## **Response to RC1**

The paper report on tests and comparison of three recent optical analyzers dedicated to measuring both CH<sub>4</sub> and C<sub>2</sub>H<sub>6</sub>. These sensors are increasingly needed for partitioning CH<sub>4</sub> emissions from the fossil fuel sector. This is a very timely study since CH<sub>4</sub> emissions from the oil and gas sector are under increasing scrutiny with the potential to achieve rapid climate change mitigation results.

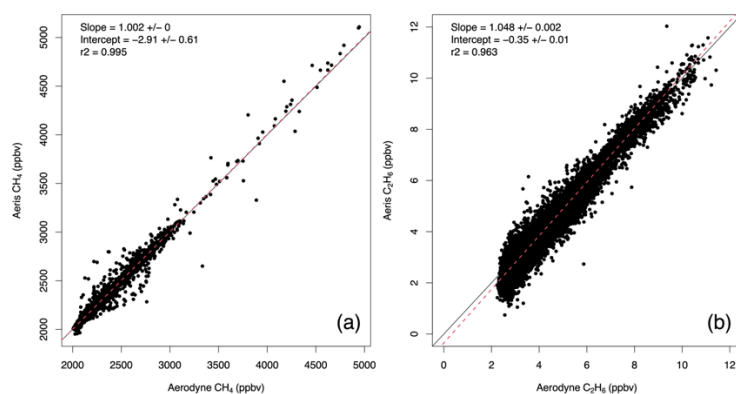
- The paper lacks discussion on linearity especially toward large concentrations that could be useful in the context of industrial applications. Do the three sensors perform equally linearly within the full concentration ranges that can be observed in near-source studies for both species?

We thank the reviewer for this suggestion. It was not possible to calibrate the methane and ethane to the high mixing ratios observed in these plumes as they are outside the range of our calibration standards. Instead, we have compared the Aeris and Aerodyne instruments for ambient plume sampling in Feb 20-21 at 1s for methane and 10s for ethane and the relationship is linear (Fig S9). This result is representative for the ambient sampling periods (including much more data caused the 1s data plots to be huge). While this does not directly test linearity, it is unlikely that the instruments would have identical non-linearities and therefore strong correlations between reported concentrations from the instruments likely indicates that they retain linear behavior well beyond the range of the span. We have added a discussion of the linearity of the Aerodyne and Aeris instruments at the end of Section 3.2 Instrument calibration.

“We evaluated the linearity of the instruments outside our range of calibration standards by comparing the instrument response for the Aerodyne SuperDUAL and Aeris MIRA during the high plumes (as discussed in Section 3.5 below). Fig S3 shows the linearity of 1s methane and 10s ethane for Feb 20-21, 2022 with the Aeris MIRA and Aerodyne SuperDUAL. The methane fit (Slope 1.002) is slightly closer to 1 than the ethane fit (Slope: 1.048 +/- 0.002). The slow response of the Picarro G2210-i meant that it could not represent plumes of ethane at sufficient resolution to allow for valid comparison. While this does not directly test linearity, the strong correlations between reported concentrations from the instruments likely indicates that they retain linear behavior well beyond the range of our calibration standards.”

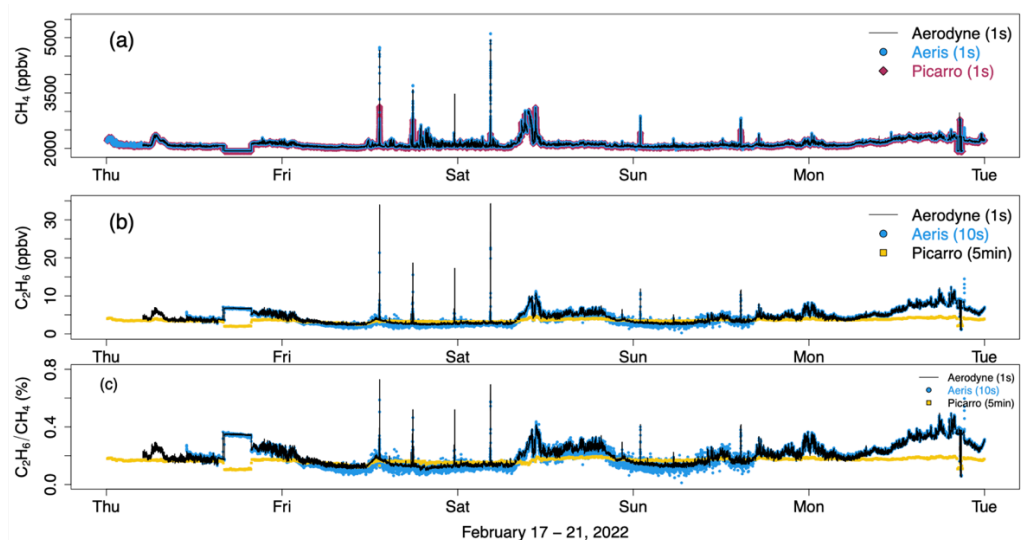
- The obvious problem about the Picarro not detecting the ambient air 10ppb C<sub>2</sub> peaks is a major concern (section 3.5). Is it representative of a shortcoming of the G2210

model, or is it just a problem with this particular unit at that particular time, mishandling or poor quality control at the factory by the manufacturer? This is an important concern that is opened by this study but is frustratingly not really addressed. Such a poor performance is useful to publish since this particular case suggest that the instrument do not work according to expectations. However if this is behaviour is not representative of the G2210 model it cannot left as it is. Further work is needed that investigates whether this poor performance is to be attributed either to shortcomings of the G2210 model or to another reason (and if there is another reason, is there hope that it can be corrected by the manufacturer or the user). In my opinion, before this paper is published this work should really be completed to address this point. Ideally by running in parallel another G2210 unit that could maybe be borrowed from the manufacturer or elsewhere. This could be done even through a few days worth of measurements close to a known C1/C2 emitter (natural gas industrial site) with only the 2 picarro.

We thank the reviewer for this comment. We struggled with how to represent the behavior of the Picarro fairly and may have erred on the side of not including enough information. We have no reason to believe that the behavior described here is specific to this analyzer. In the few papers that reported using the G2210-i analyzer (e.g. Lebel et al., 2022, Defratyka et al., 2021), no ethane data has ever been plotted/shown in a figure. Methane reported by the analyzer is within spec provided by Picarro and the methane isotopes (not evaluated here) also seem to be reporting accurately (based on some brief testing at the isotope lab in Rochester).

This particular G2210i analyzer was operating for over a year at a background site where it was reporting somewhat unexpected behavior (negative ethane concentrations, anticorrelations of ethane with methane, etc). The instrument was returned to Picarro for service, where it was kept for a few months before it was returned to the PI and we conducted this study soon after. When we received the analyzer, we were assured by Picarro engineers that it was functioning as expected and completely within specifications. What we don't show here is all the negative ethane concentrations and the anticorrelation with methane (obviously a malfunction) that we observed in the first two weeks of our study. We contacted Picarro after the two weeks and spent over ten hours on various meetings with engineers and scientists at Picarro trying to understand the behavior described here, specifically showing them the negative response for ethane vs the other analyzers. We informed them that we were working on this manuscript and gave them opportunity to deal with the problem before we submitted. However, they failed to identify a problem, other than it *might* be a CO or VOC interference from the combustion, and no solution was presented. They never offered to send a second analyzer for additional comparison and we would not suggest that anyone should spend money buying one. The analyzer was returned to the background site (with little CO) after this study and seems to be operating within specifications since then.

We have added the following (blue) text to Section 3.5:

“In order to test the suitability of each analyzer to report accurate methane and ethane mole fractions in ambient air, we ran all instruments sampling ambient air from the CUNY Observatory in Harlem, NY, for 3-4 weeks in February 2022. In general, air is cold and very dry in New York City in winter and it took some time to learn that we had to humidify the Aeris MIRA and Picarro G2210-i sample flows in order to record valid data (see instrument

characterization experiments described above). The Picarro G2210-i was often reporting negative ethane and negative correlations of ethane with methane for the first two weeks of observations. We then requested that Picarro engineers check the instrument and they assured us it was performing as expected. So we have focused on Feb 17-22, 2022 (see Fig S8), when the G2210-i was confirmed to be performing to specification. Figure 4 shows typical zoomed in examples of the ambient methane and ethane mole fractions observed by all the analyzers when sampling ambient air in February 2022.”

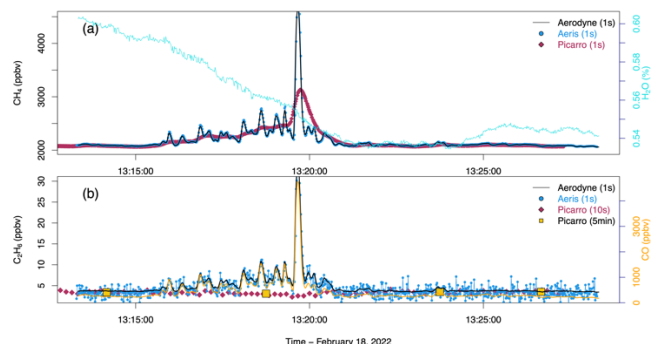
L287 : difficult to see the longer CH<sub>4</sub> peak duration in the figure

We have added Figure S9 to the supplement with a zoomed in 20 mins around the peak of this plume. Fig S9 shows the slower reduction in methane from the Picarro vs the other instruments. At the request of another reviewer, we also included water vapor and CO to the plot.

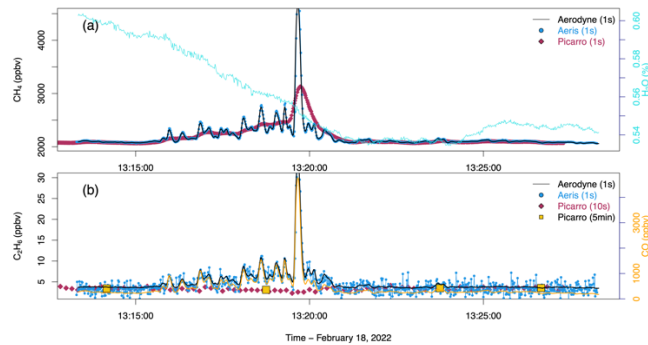
Line 273 - Figure4: As water vapour has been shown to be a critical component please add the H<sub>2</sub>O levels to the plot. Are there any changes in H<sub>2</sub>O reported by the Picarro during the expected C<sub>2</sub>H<sub>6</sub> peaks. Previous studies have shown strong dependencies. <https://doi.org/10.5194/amt-14-5049-2021>

We have corrected each instrument for water vapor dependence (as per Section 3.1). But, unlike Fig 3 in Defratyka et al., 2021, the water vapor dependence of the ethane reported by the G2210-i was negligible (See Figure 1) so we do not expect a water vapor response in the ethane signal. Adding water to Fig 4 was a bit messy so we have shown the reported water in the zoomed in version (Fig S9). We also added CO to highlight the combustion character of the plume.

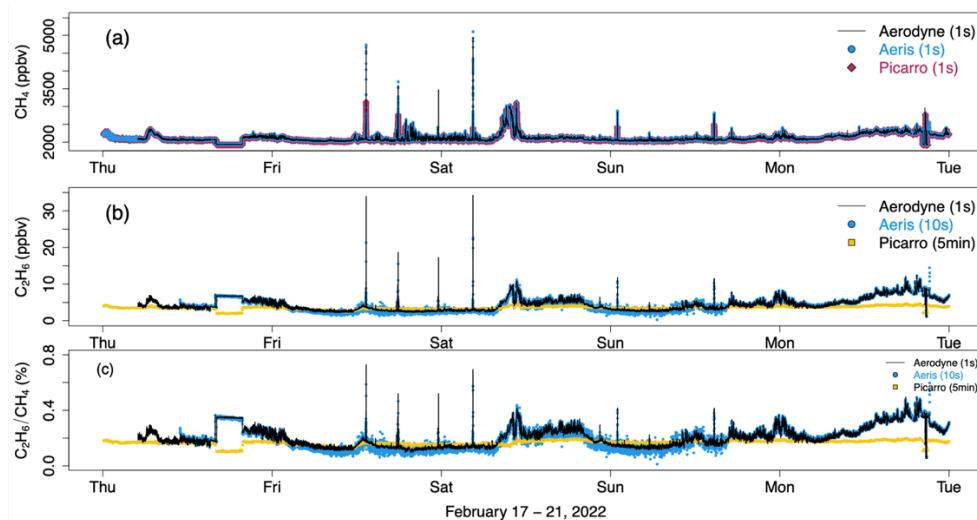
Line 303: Generally restricting the use of G2201-i Picarros in certain regions seems an extreme suggestion given that the real-world test period was extremely short and only performed in one region.

We do not comment on the G2201-i as it was not evaluated here. We are asserting that the G2210-i evaluated here is not appropriate for use in some conditions such as the specific urban polluted air as sampled here. We have added a new Figure S8 to show some of the longer time series of observations when all three instruments were sampling ambient air and we have added the following (blue) text to Section 3.5:

“In order to test the suitability of each analyzer to report accurate methane and ethane mole fractions in ambient air, we ran all instruments sampling ambient air from the CUNY Observatory in Harlem, NY, for 3-4 weeks in February 2022. In general, air is cold and very dry in New York City in winter and it took some time to learn that we had to humidify the Aeris MIRA and Picarro G2210-i sample flows in order to record valid data (see instrument characterization experiments described above). The Picarro G2210-i was often reporting negative ethane and negative correlations of ethane with methane for the first two weeks of observations. We then requested that Picarro engineers check the instrument and they assured us it was performing as expected. So we have focused on Feb 17-22, 2022 (see Fig S8), when the G2210-i was confirmed to be performing to specification. Figure 4 shows typical zoomed in examples of the ambient methane and ethane mole fractions observed by all the analyzers when sampling ambient air in February 2022.”

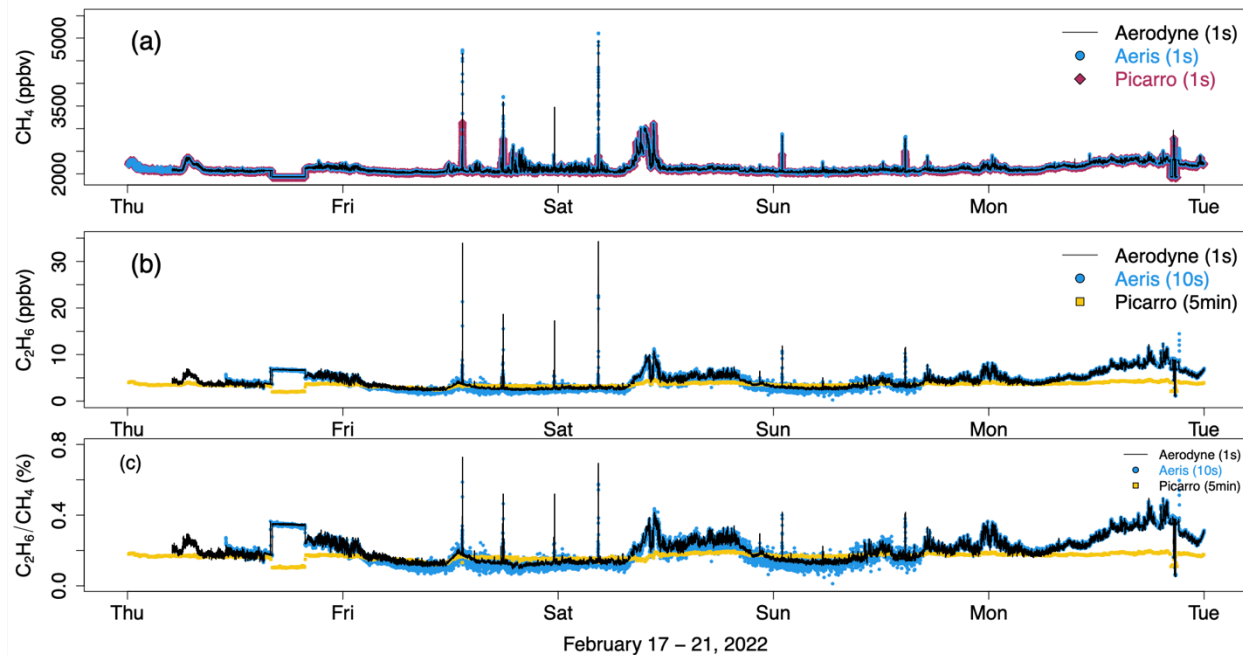
Main concern – You do not recommend the usage of Picarro compared to both other instruments but only based on the 2 unrealistic ethane measurements during the plumes. If I understand correctly all the other tests and calibrations were qualitatively indifferent or not significantly worse when using Picarro. Following those findings, I would conclude that future research on the Picarro instrument measuring ethane plumes is needed (as you “only” measured twice) rather than only recommending the other two instruments. One idea could also be to leave the ambient sampling experiment out of the paper until more samples and a concluding review can be reached.

We thank the reviewer for highlighting this point. We had struggled with how to best describe the behavior of the G2210-i fairly and now realize that we didn’t include enough information. We had 4 weeks of ambient sampling in February 2022 but for the first two weeks, the G2210-i instrument either reported negative ethane concentrations or showed anticorrelation of ethane with methane (when the Aeris and Aerodyne showed positive correlations). The two examples shown in Figures 4 are just short examples of the longer-term ambient sampling, zoomed in for ease of viewing. We saw many of these type of events in Feb 2022. We have now added Fig S8 that shows 5 days of all three instruments sampling ambient air in NYC. The same G2210-i was also operated at an air quality site for over a year and showed similar behavior (negative ethane during plumes).

We have added the following (blue) text to Section 3.5:

“In order to test the suitability of each analyzer to report accurate methane and ethane mole fractions in ambient air, we ran all instruments sampling ambient air from the CUNY Observatory in Harlem, NY, for 3-4 weeks in February 2022. In general, air is cold and very dry in New York City in winter and it took some time to learn that we had to humidify the Aeris MIRA and Picarro G2210-i sample flows in order to record valid data (see instrument characterization experiments described above). The Picarro G2210-i was often reporting negative ethane and negative correlations of ethane with methane for the first two weeks of observations. We then requested that Picarro engineers check the instrument and they assured us it was performing as expected. So we have focused on Feb 17-22, 2022 (see Fig S8), when the G2210-i was confirmed to be performing to specification. Figure 4 shows typical zoomed in examples of the ambient methane and ethane mole fractions observed by all the analyzers when sampling ambient air in February 2022.”
